Three Mile Island Nuclear Station, Unit 2 (TMI-2)
License No. DPR-73
Docket No. 50-320
Reactor Containment Building Atmosphere Cleanup

Enclosed are the responses to the 33 questions raised in your letter of December 18, 1979. If you need further explanation of these responses to complete your Environmental Assessment, please contact Mr. Ed Fuller at (201) 263-6331. We would be pleased to meet with you to discuss our responses if that would expedite the NRC review and approval of our requests to proceed with purging the TMI-2 Reactor Building.

FIGURE 2

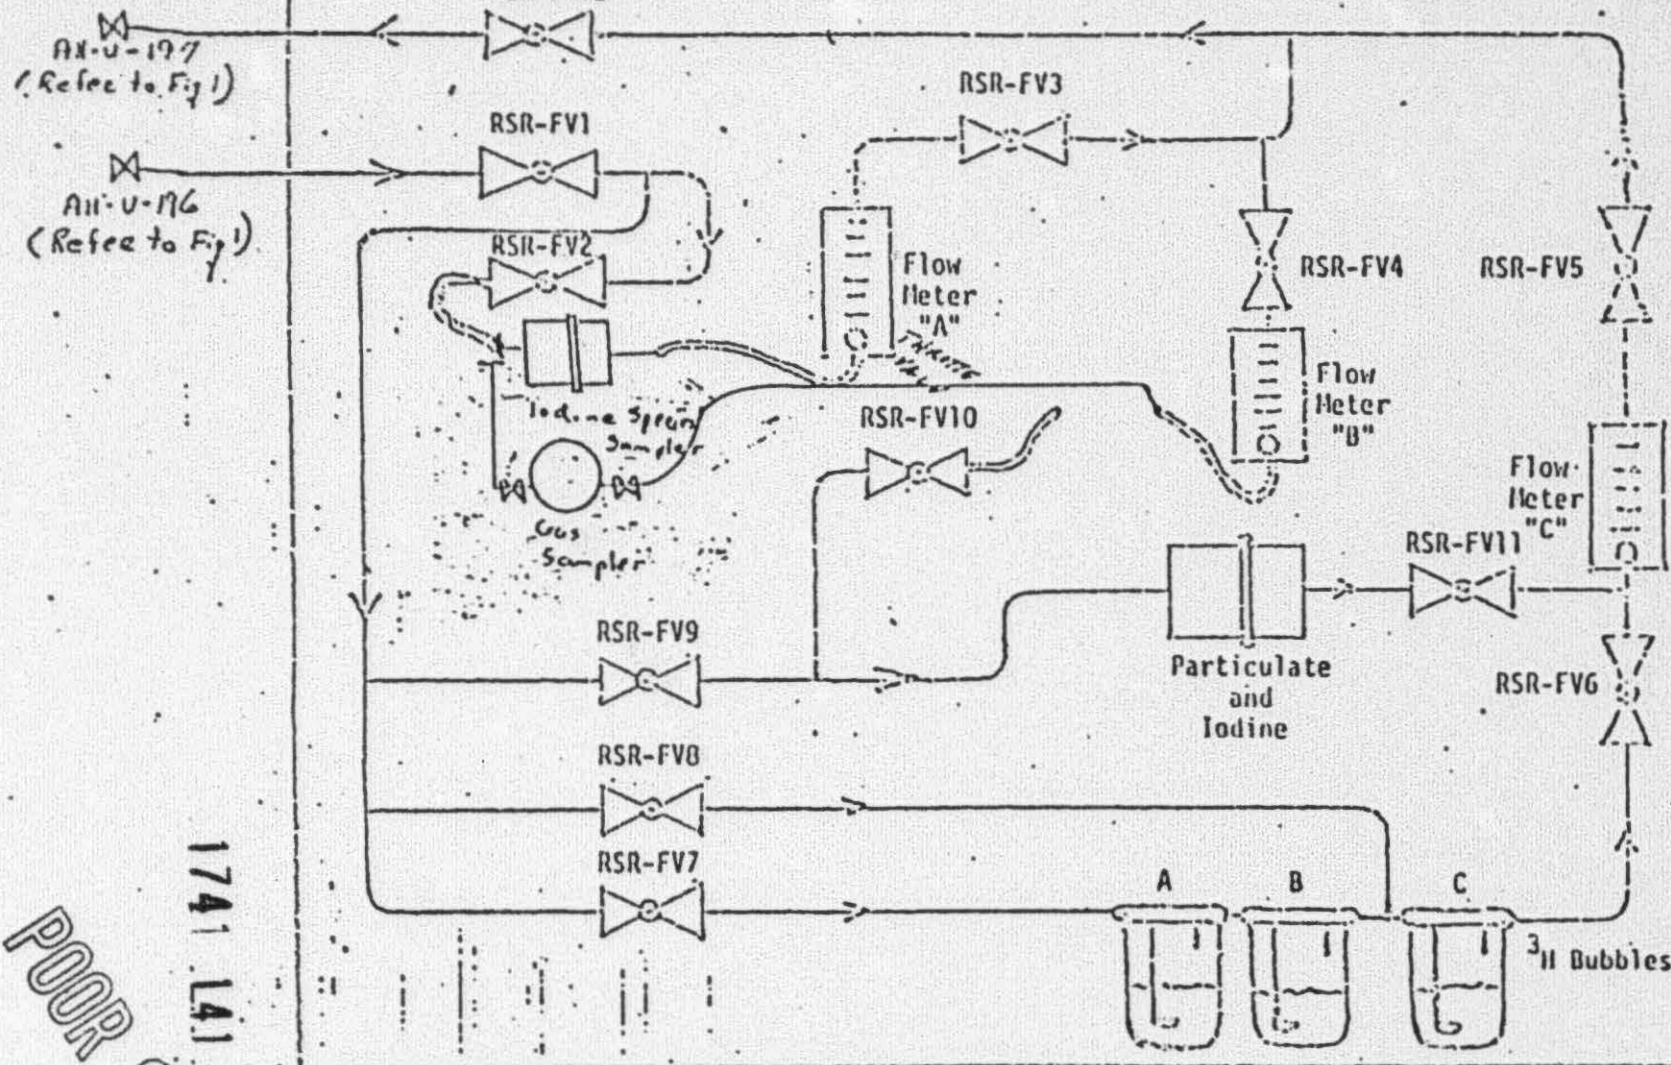
Provide a description of the radiation monitor.

HP-R-227 is a sample panel, not a radiation monitor, which allows direct sampling of the reactor building atmosphere. The sample panel can be used to fill a sample bomb for gas analysis, to perform a particulate analysis by drawing containment air through a filter, or to perform a tritium analysis by using the installed bubbler. The attached system sketches provide details of the sample system.

FIGURE 10. CALCULATED VERSUS EXPERIMENTAL BREAKTHROUGH CURVES

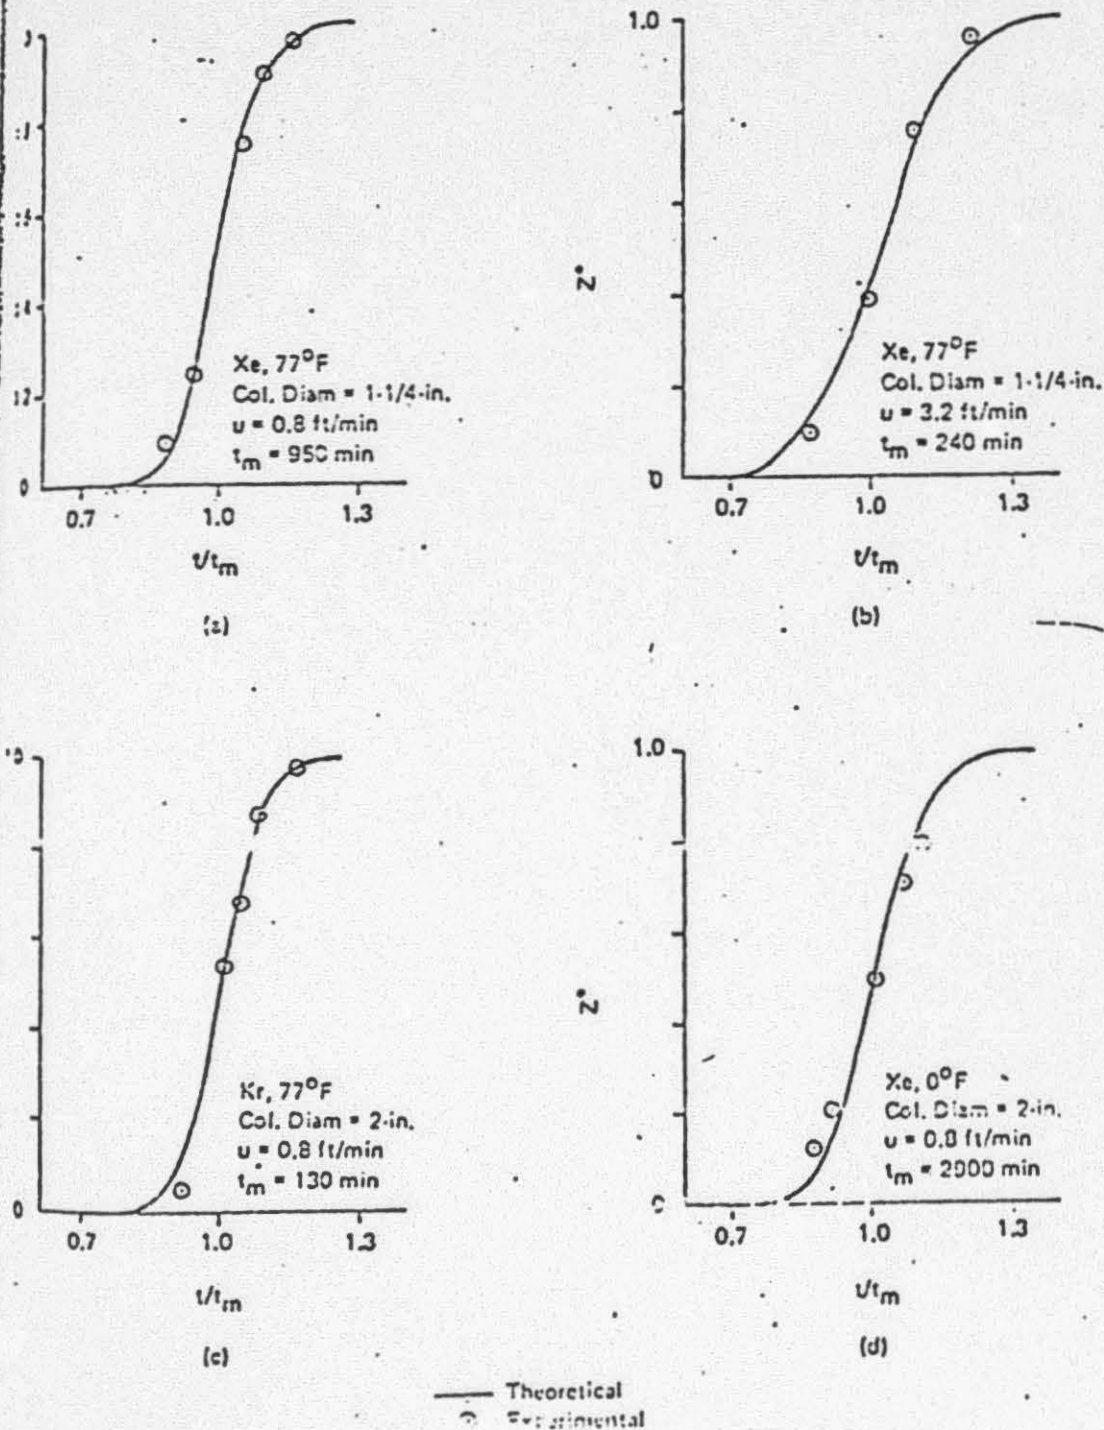
Provide the basis for the 34,000 tons of charcoal stated in this section. Provide justification as to why it is necessary to design and construct the tanks to Section III, Class 3.

From Figure 10 of NEDO-12327, the time to "break-through," t_b , is on the order of $0.7 t_m$.

PRELIMINARY SCHEDULE
TIME (MONTHS)

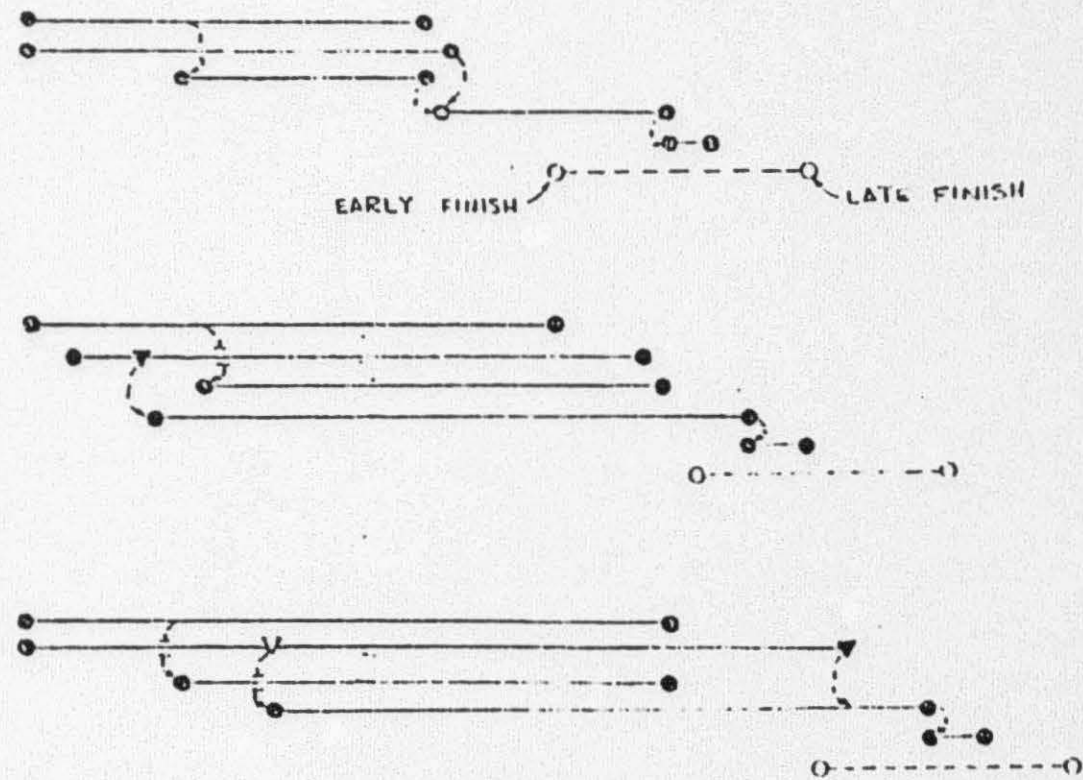
Provide a detail breakdown to justify why it will take 30 to 40 months to design and construct this system.

In order to evaluate the effort required to place the alternate systems into operation, Metropolitan Edison performed a scoping evaluation which included a preliminary system design for each alternate. These preliminary systems were then evaluated by Metropolitan Edison's architect engineer to determine schedule and costs for implementing the systems. The schedule determined is as shown in the attached bar chart. Our architect engineer used standard industry estimating and scheduling techniques to determine the times and costs presented. The cost and schedule estimates are based on years of experience and considered judgement and are considered adequate for use by Metropolitan Edison. A more detailed estimate would require greater design detail, which would impose additional, unwarranted delays in solving the Krypton-85 problem.
